CORRESPONDENCE

Lauzon Parkway Improvements Class Environmental Assessment Notice of Study Commencement

Attachment 2: WCF Proposed Roundabout September 24, 2013

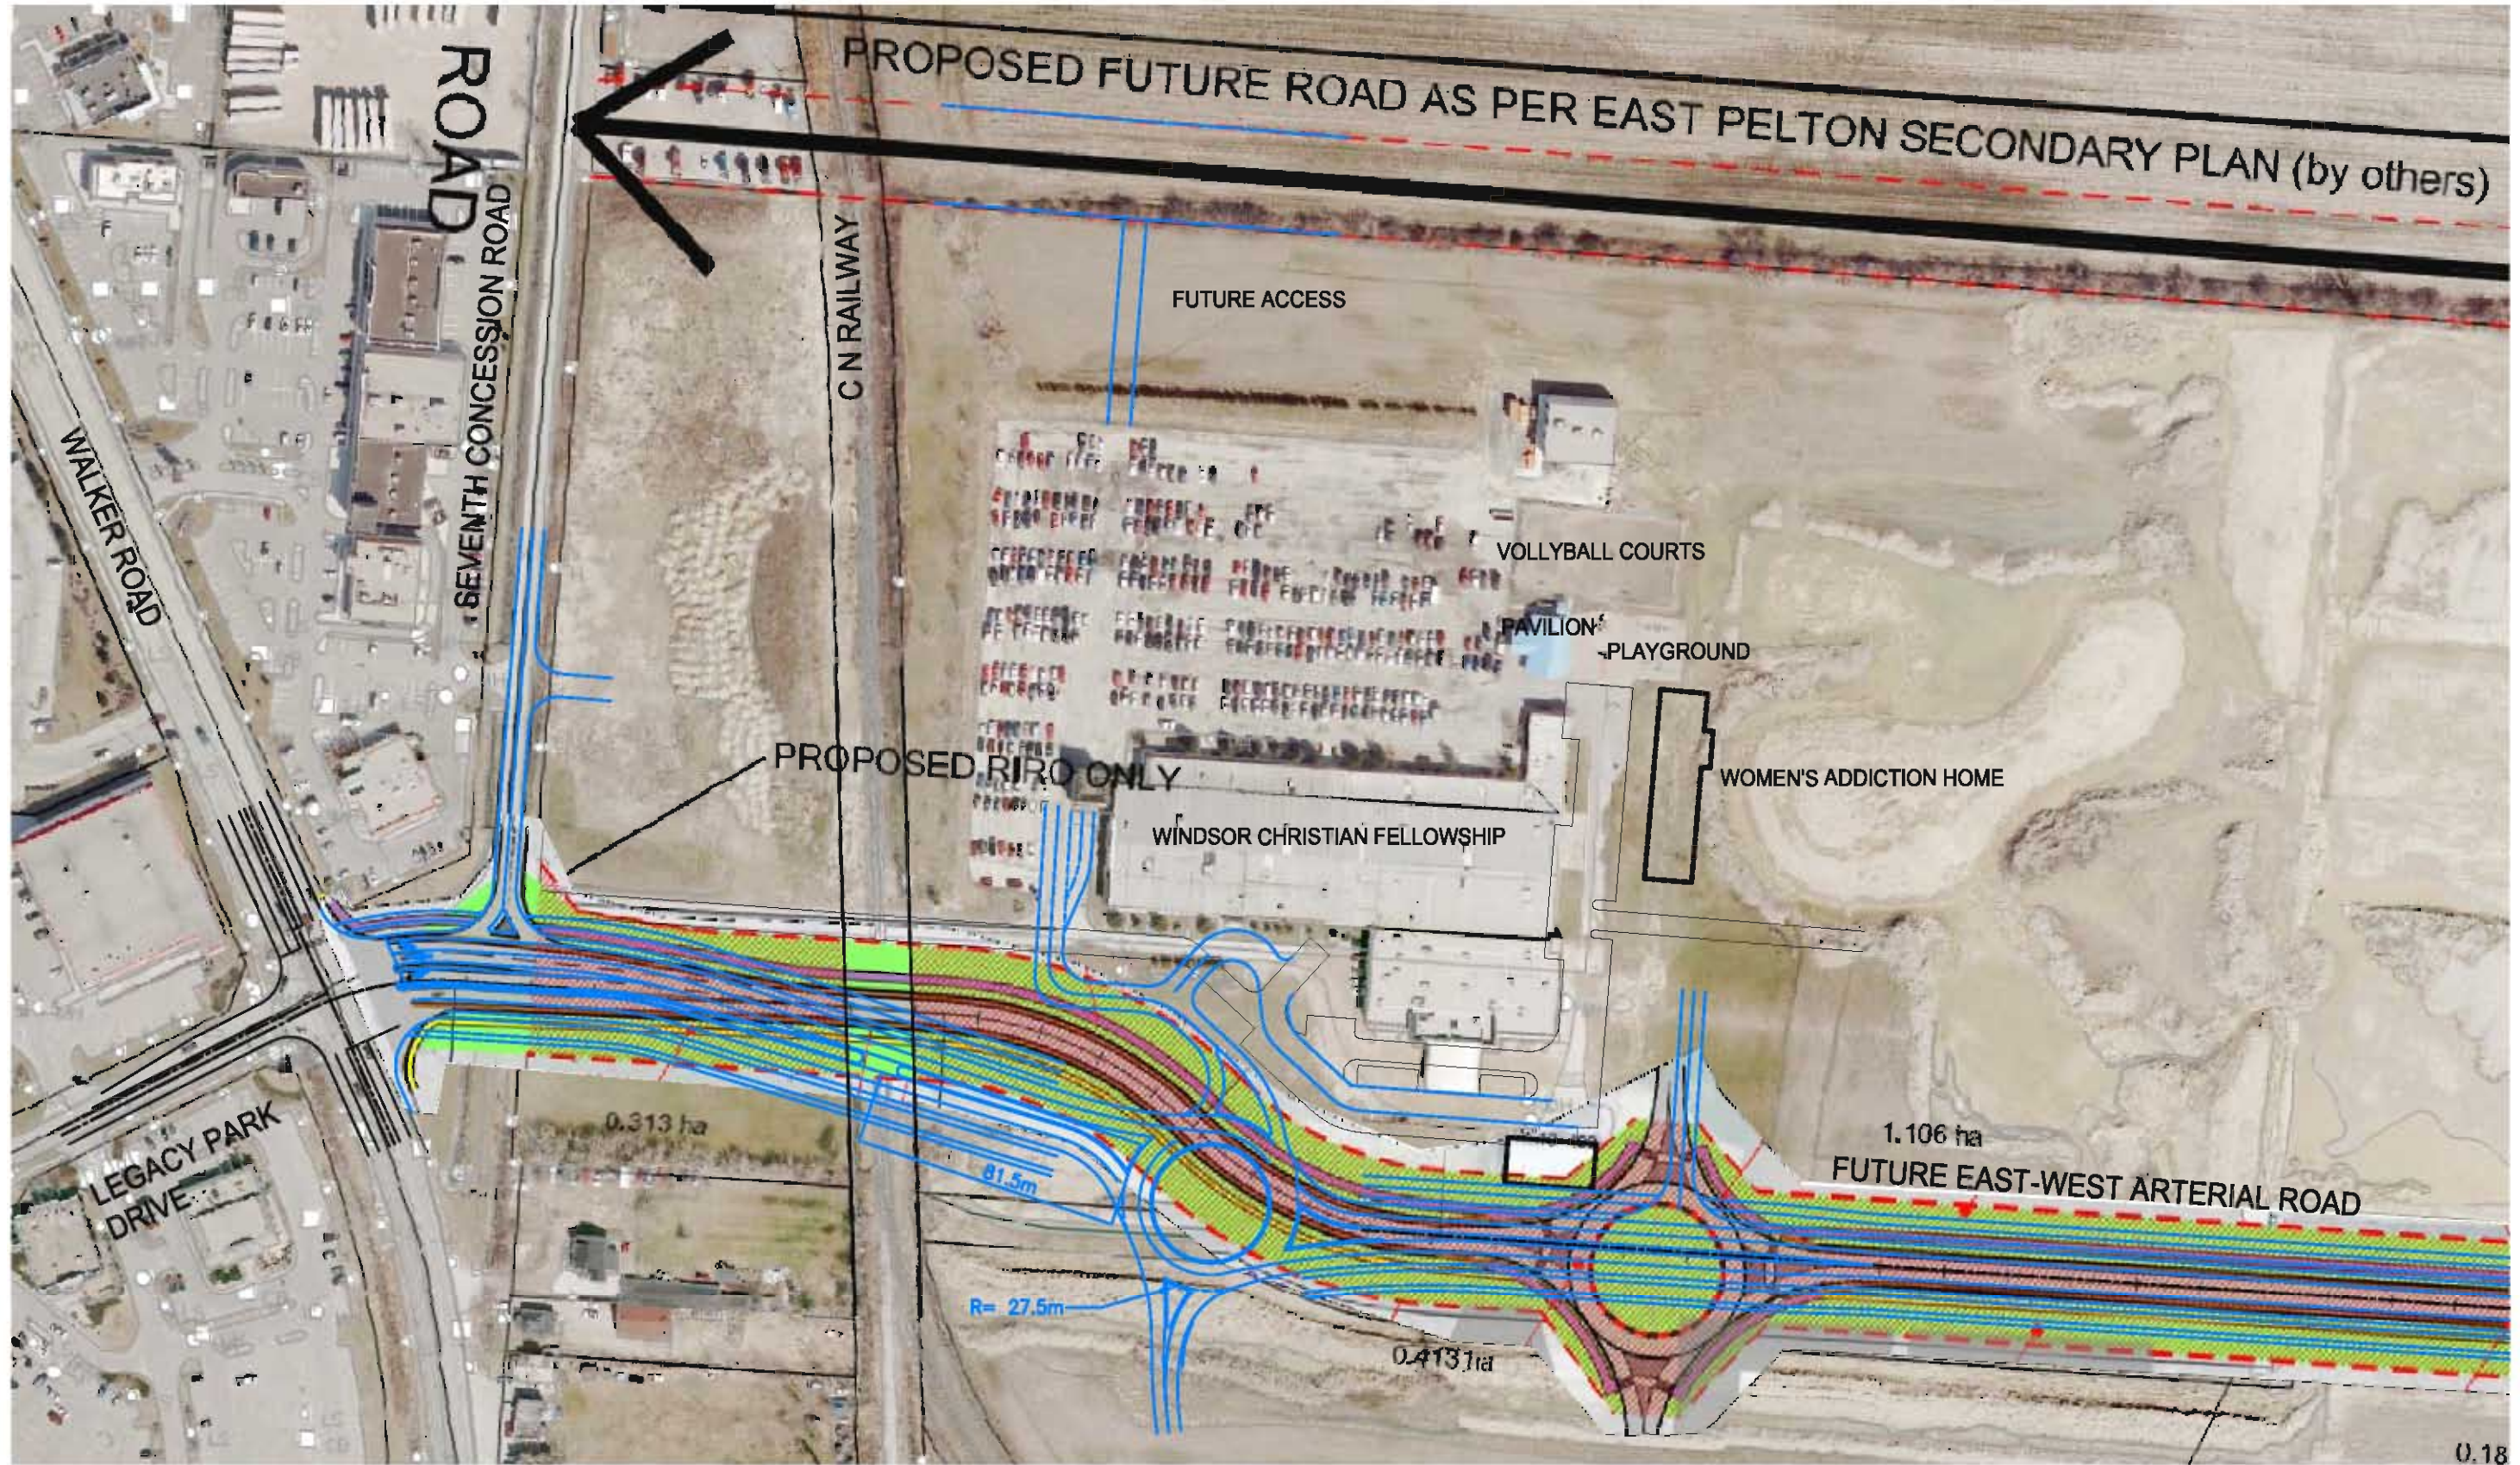
eastbound approach could extend beyond the available storage of 85 m between the roundabout and the CN Rail line and could result in queues extending over the CN Rail line and a conflict at the rail crossing.

- It is noted that the WCF Proposed Roundabout plan includes two proposed accesses on E-W Arterial (roundabout + RIRO) to 4490 7th Concession Road and identified a third access on the north side of the property (4490 7th Concession Road).
- The EA Recommended Plan proposed roundabout access location is aligned with an easement that runs north-south through the property to the south (property roll #90010018000000), which is intended as the future access to the south property.
